Product Change Notice: OS-CON Conductive Polymer Aluminum Solid Capacitors

PCN.PG13.12.11.2018

12.11.2018

• Bulk packing

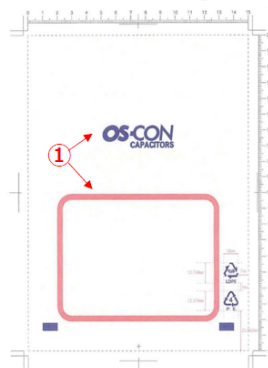
- ① Delete "Red frame" and "OS-CON" logo : The "OS-CON" logo is displayed on the C3 label.
- * No change material and size.
